27.10.2020

Our Ref: 34807-002-01
Your Ref: MCUC 2020/3524/1

Information Request Response
Development Application for Material Change of Use – Retirement Village
111-119 Port Douglas Road, Port Douglas – Lot 3 on RP729991

PROPOSED DEVELOPMENT ON LOT 3 OF RP72991	
PLAN OF DEVELOPMENT	
CONCEPT ENTRANCE ARRANGEMENT	
DRAWING NO.	REVISION
188-002-SK06	1

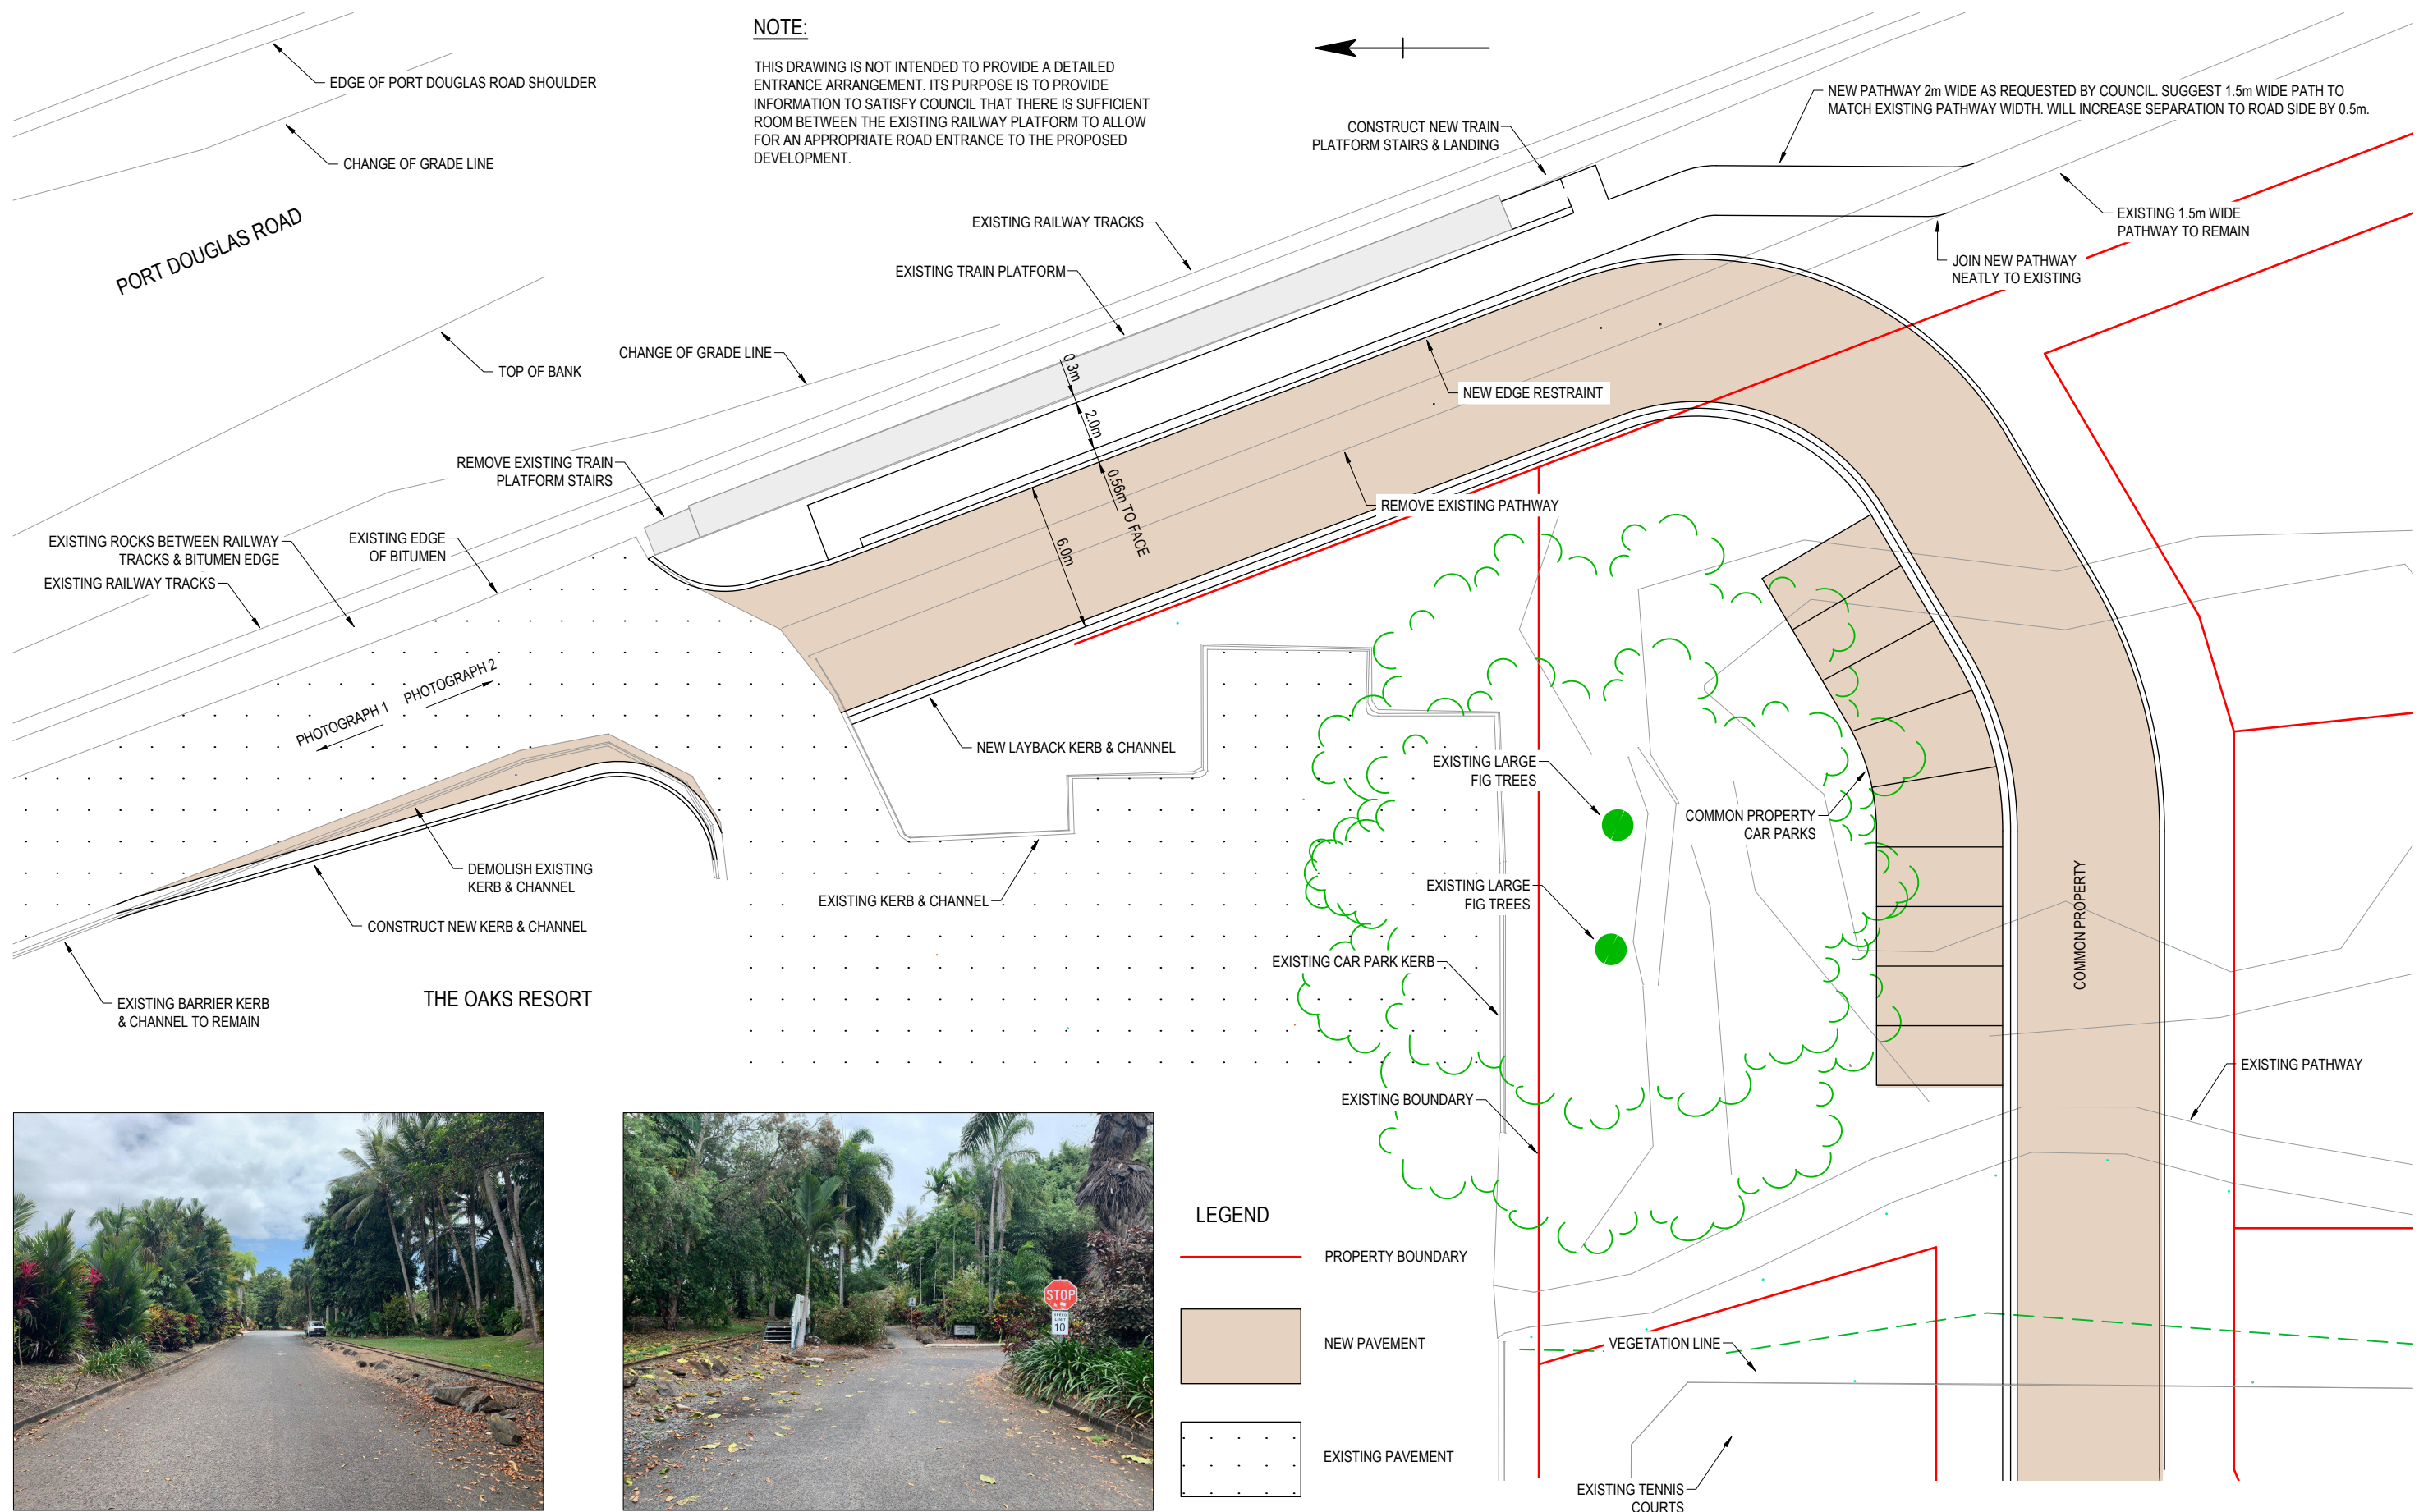
9. Confirm via a detailed plan drawn to an appropriate scale that the on-street works, including the access driveway and a two (2) metre wide footpath can be accommodated while retaining the tram station in its current location.

Refer to Engineering response within *Attachment A*, prepared by Civil Walker Consulting Engineers.

PROPOSED DEVELOPMENT ON LOT 3 OF RP72991	
STORMWATER DRAINAGE CATCHMENT PRE-DEVELOPMENT SCENARIO	
DRAWING NO.	188-002-SK10
REVISION	1

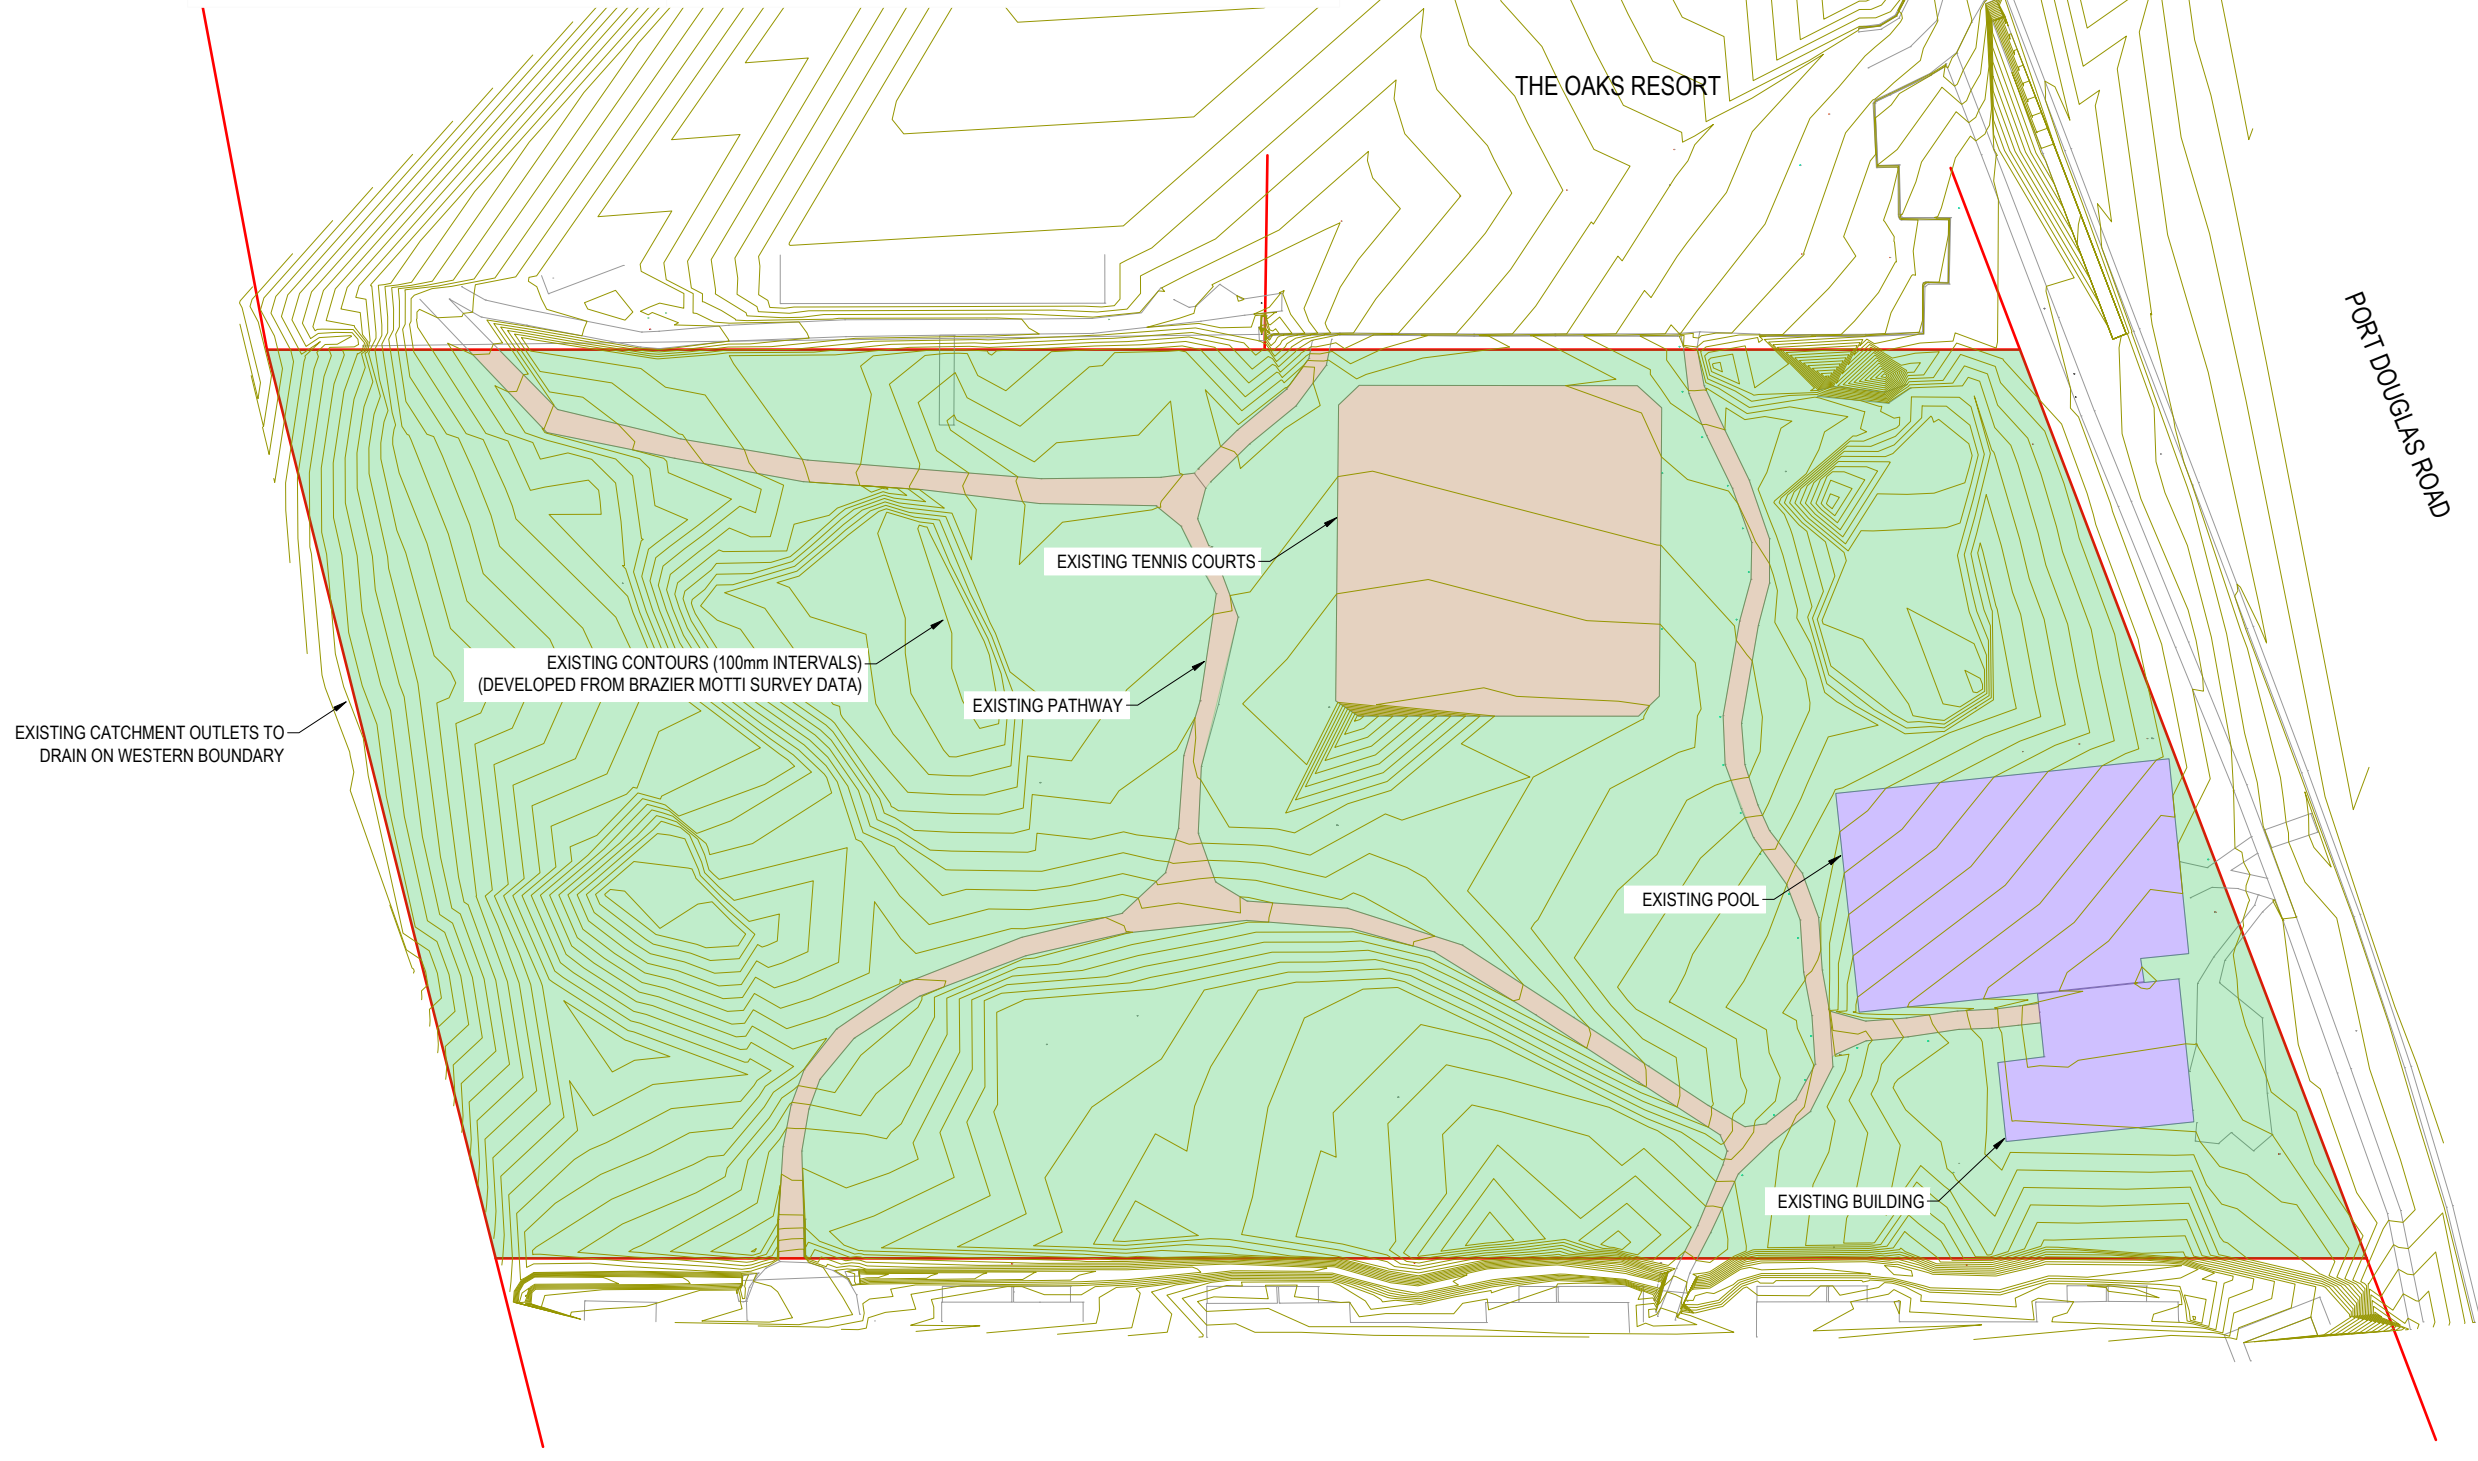
1. *Undertake a local drainage study of the site to determine the drainage impacts on upstream and downstream properties and the mitigation measures required to minimise such impacts. In particular, the study must address the following:*
 - a. *The contributing catchment boundaries;*
 - b. *The extent of the 1% AEP (100 year ARI) flood event in relation to the site both pre- and post-development. Note: the operation of the adjacent open drains needs to be considered in addressing this point;*
 - c. *Primary and secondary flow paths for the 5, 10 and 100 year ARI flood events. Note: advice on the flows discharging from the adjoining site to the south via its internal road system and the open drain along the common boundary must be considered in providing a response to this item. Cross sections showing the pre and post development drain profile must be included;*

Reference is made to drawing 188-002-SK10 which identifies the adopted existing contributing catchment characteristics from the existing site in the pre-development scenario. We have conservatively allowed for the entire site area to contribute to the proposed outlet location. It is noted that a portion of the site on the northern boundary falls northward to The Oaks resort car park and a portion of the site on the southern boundary falls southward into the adjacent properties open drainage channel.

The pre-development 100-year flood event was calculated adopting the rational method in accordance with the procedures nominated within Section 4 of the 4th Edition of QUDM (Queensland Urban Drainage Manual). Referencing drawing 188-002-SK10, the catchment contributing to the proposed outlet is 17,449m². Calculation of Q100 flow from the catchment is as follows:

- fraction impervious adopted at 0.18 (refer drawing 188-002-SK10 for details)
- 1 hour 10-year intensity for Port Douglas = 81.16mm/hr (refer FNQROC IFD Chart 18)
- C₁₀ co-efficient of runoff = 0.74 (refer QUDM Table 4.5.3)
- Frequency factor = 1.20 (refer QUDM Table 4.5.2)
- Therefore, C₁₀₀ = 1.20 x 0.74 = 0.89
- Time of Concentration = 26 minutes (based on overland flow at 3.6m fall over 235m; average grassed – Figure 2.4 QUDM), adopt 25 minutes.
- 25-minute 100-year intensity = 176.15mm/hr (refer FNQROC IFD Chart 18)
- Adopting the rational method in accordance with Section 4.3 of QUDM,
